**MODIFICATION REPORT
SHOALHAVEN HOSPITAL REDEVELOPMENT
SSD - 35999468 – MOD 5**

PART A – MAIN REPORT

DECEMBER 2025

MODIFICATION OF CONSENT (SECTION 4.55(1A)) MOD 5 – 35999468 SHOALHAVEN HOSPITAL REDEVELOPMENT SCENIC DRIVE, NOWRA

Figure 1 – Approved building identification signage (Conrad Gargett)

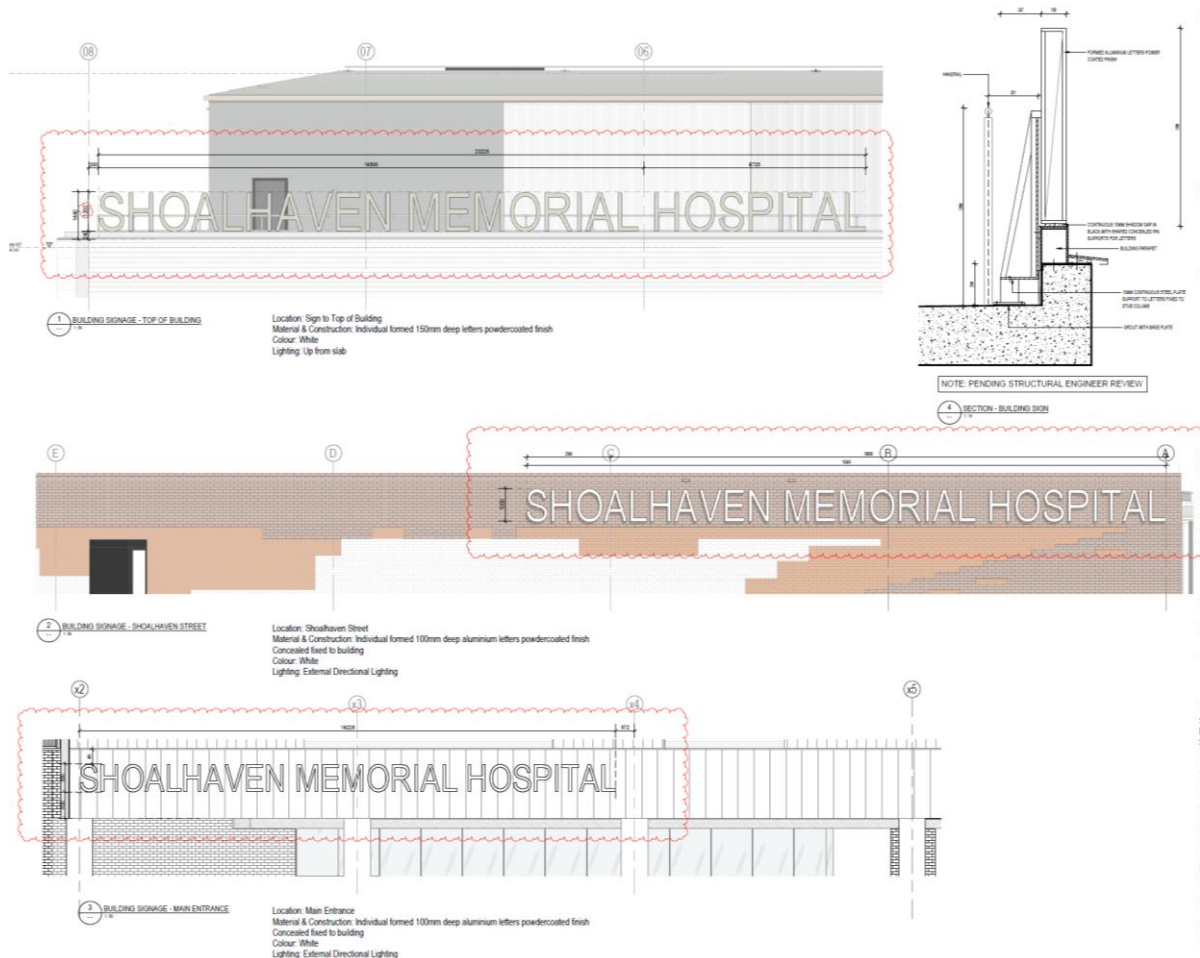
The sky sign at the top of the Acute Services Building was approved as a building identification sign stating 'Shoalhaven Hospital' with an area of 55.4m². The other signs stated 'Shoalhaven District Memorial Hospital' and ranged in size / area from 19.4m² to 26m². See the approved signage in **Figure 1** over.

This is proposed to be refined to consistently state 'Shoalhaven Memorial Hospital'. The reason for this change results from the HI's and LHD's now preferred naming convention for the hospital.

The changed signage results in a smaller area of building identification sky signage (27.87m²), and is still proportionate to the scale of the building and its rooftop appearance. The Shoalhaven Street signage is now proposed at a reduced 16.8m², with the main entry signage also proposed at a reduced 13.79m². The appearance, materiality, and lighting is as previously proposed and approved. The signage is also proposed in the same locations as approved – see **Figure 2**.

Figure 3 – General location of the approved batter (as circled in red) to be replaced with new retaining wall (Site Image)

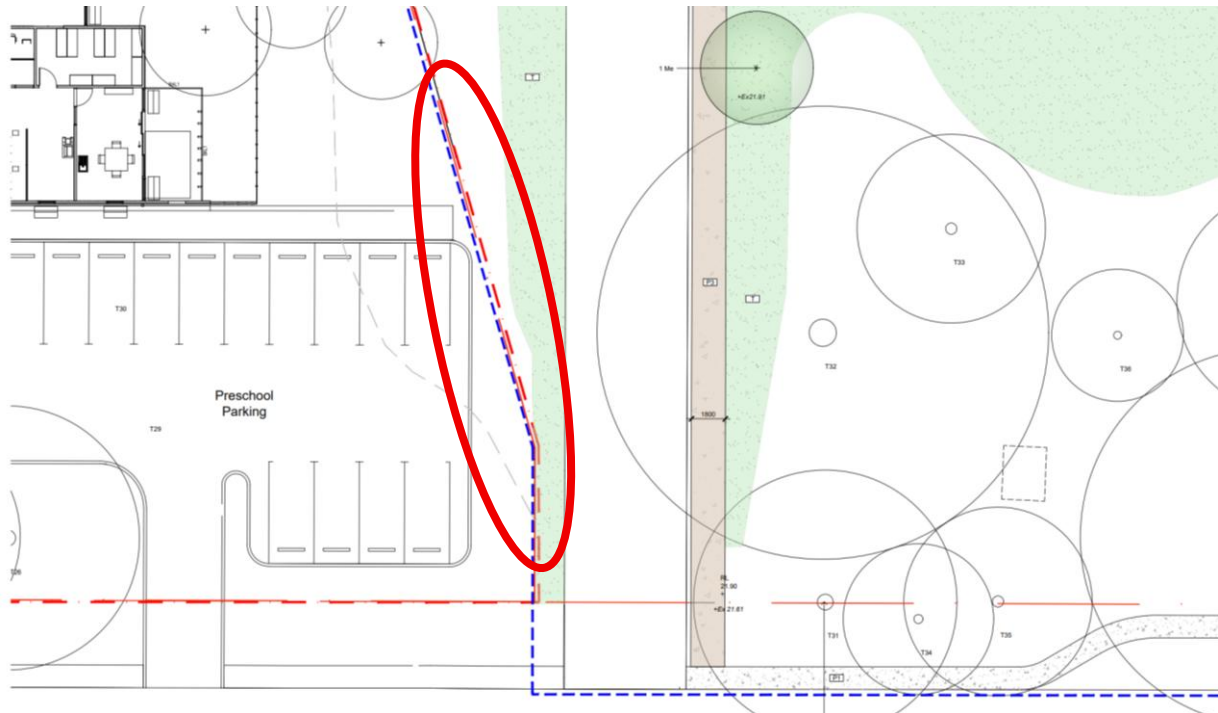
The new hospital entry road was approved with a turfed batter to address the grade change between the immediately adjacent Shoalhaven Community Pre-School's at-grade car park and the new entry road. **Figure 3** below indicates the general location of the approved batter.

A review of the engineering design has determined that a retaining wall is now the preferred outcome to effectively address the localised grade change in this location and ensure for the appropriate (and safe) engineered solution. **Figure 4** over provides for the preferred retaining wall location and design.

Figure 4 – Location and design of proposed retaining wall (Conrad Gargett / Architectus)

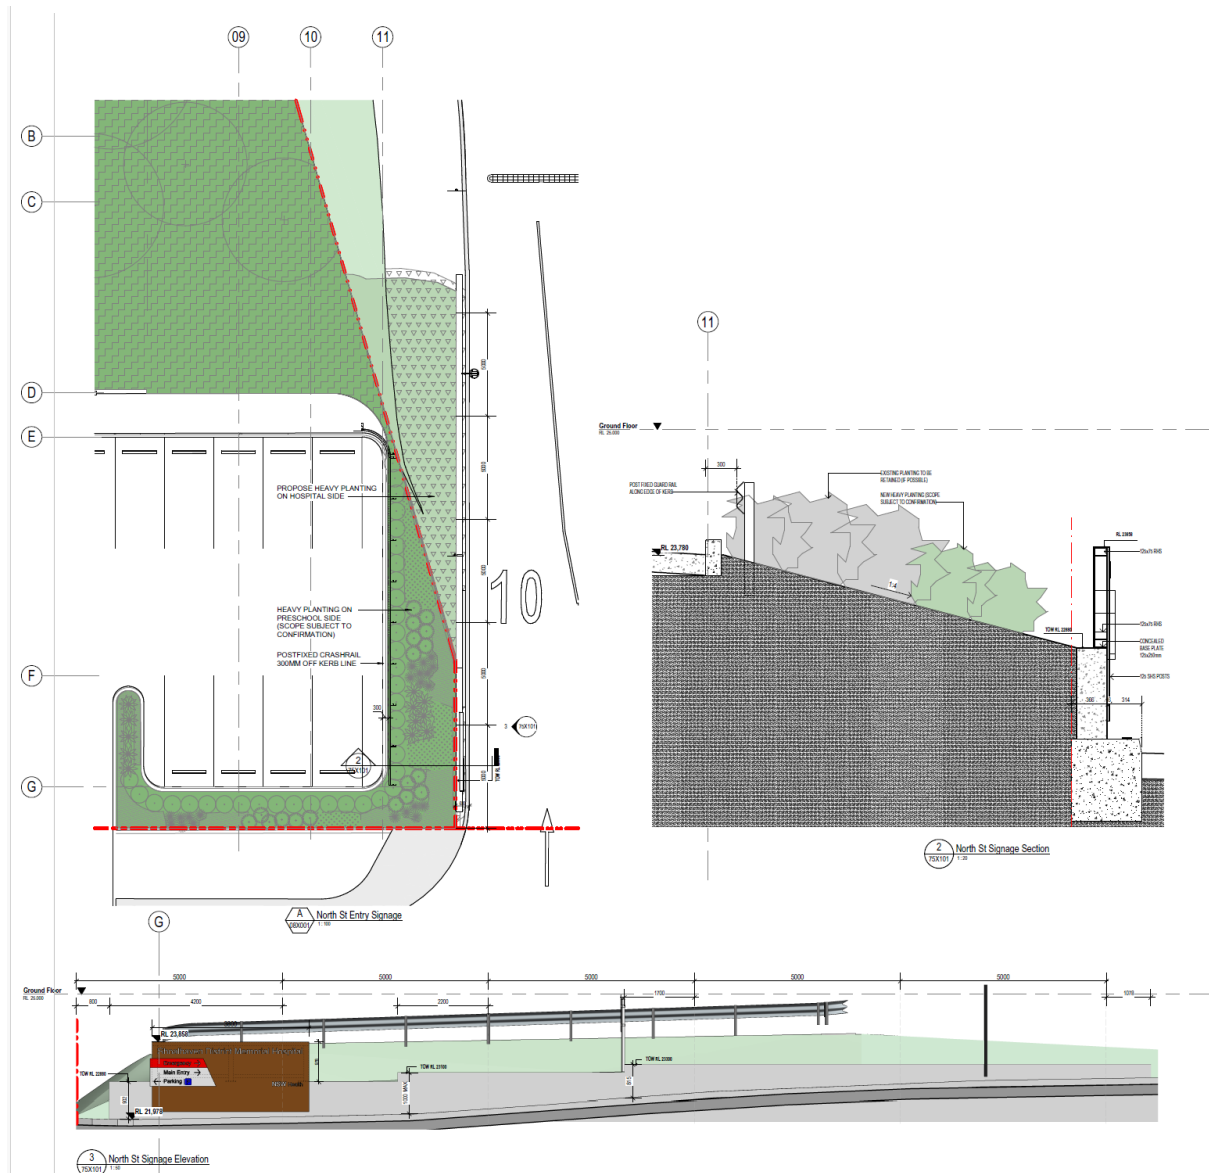
The height of the wall is proportionate to its function and purpose. Its maximum height is documented at 1.00m but is generally at a lower height ranging from 0.815m or 0.902m and tapering to lower heights as the grades flatten inwards of the hospital. No formal landscaping was proposed or approved in this location previously, and correspondingly, no new or different formal landscaped outcome is proposed within the hospital land, noting pre-existing planting exists on the Shoalhaven Community Pre-School side of the boundary and at its grades.

Part of the new retaining wall also includes wayfinding and building identification signage which is minor in scale and is included for approval.
